AMENDMENTS TO THE DRAWINGS

AMENDMENT UNDER 37 C.F.R. § 1.111
U.S. Application No. 10/821,944

Attorney Docket Q81061

FIG. 3

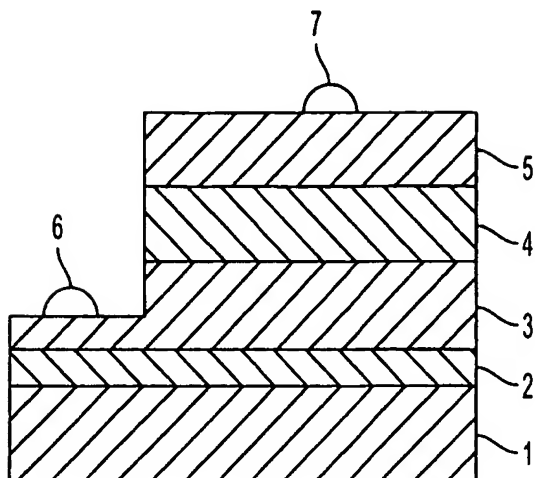
Fig. 3 has been amended to include the legend --Prior Art-- since a conventional GaN-type compound semiconductor device is depicted.

The Examiner objects to the drawings because Fig. 3 should be designated by a legend such as --Prior Art-- because only that which is old is illustrated.

The background section of the application refers to Fig. 3 as showing an example of a conventional GaN-type compound semiconductor device. Therefore, Fig. 3 has been designated by the legend --Prior Art--.

-- Prior Art --
